November 9, 2016

Re: Pescadito Environmental Resource Center - Webb County
Municipal Solid Waste (MSW) Permit Application No. 2374
Technically Complete Permit Application Supplement Number 3
Tracking Nos. 20877533 and 20683791; CN603835489/RN106119639

CB&I Environmental and Infrastructure, Inc. (CB&I) is providing the attached information to supplement the referenced permit application which was declared technically complete on March 11, 2016. We are providing these changes based on your e-mail request dated October 11, 2016 and in an effort to make the application abundantly clear on the issues. As requested in your e-mail, each specific item of concern is cited below followed by our response:

III-F.1-1 Groundwater Monitoring System Plan	1
III-F.1-2 Typical Groundwater Monitoring Well Detail.....	2

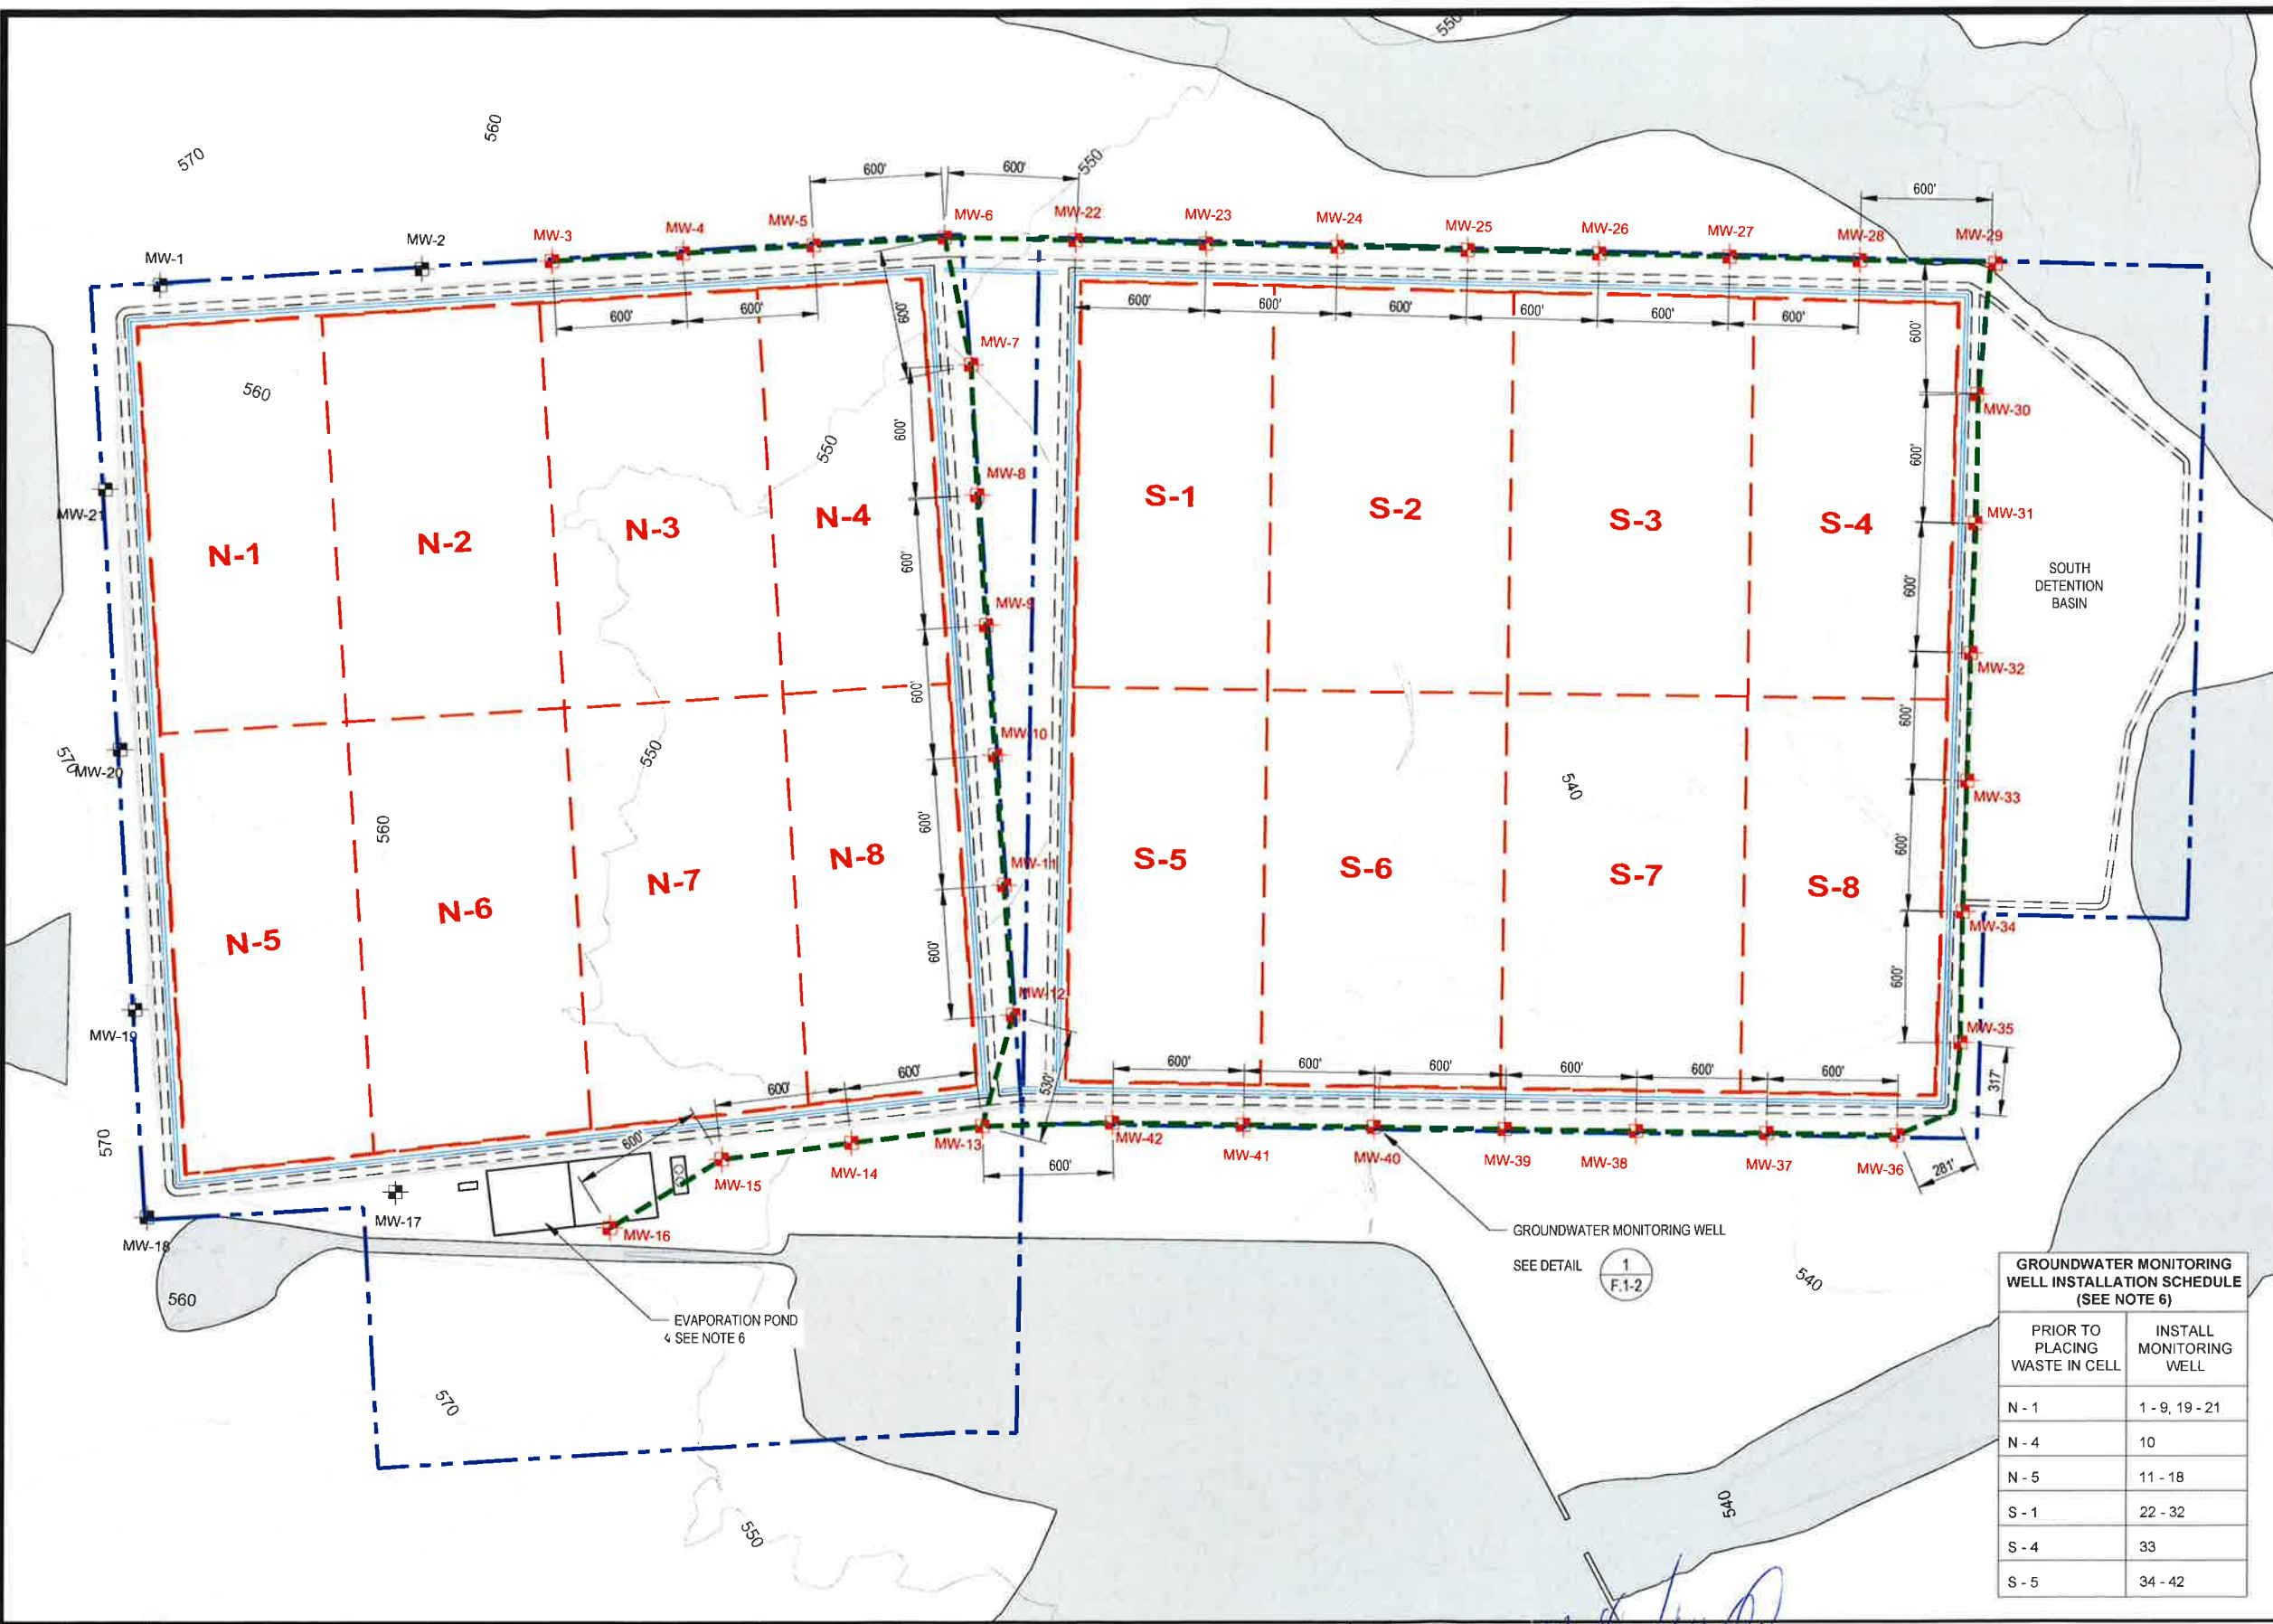
Figure III-F.1-1, Groundwater Monitoring System Plan has been modified to clearly reflect that groundwater monitoring wells must be installed around the evaporation pond prior to its use. A modified Cover Page, Table of Contents and Figure III.F.1-1 are provided for Part III, Appendix III-F.1.
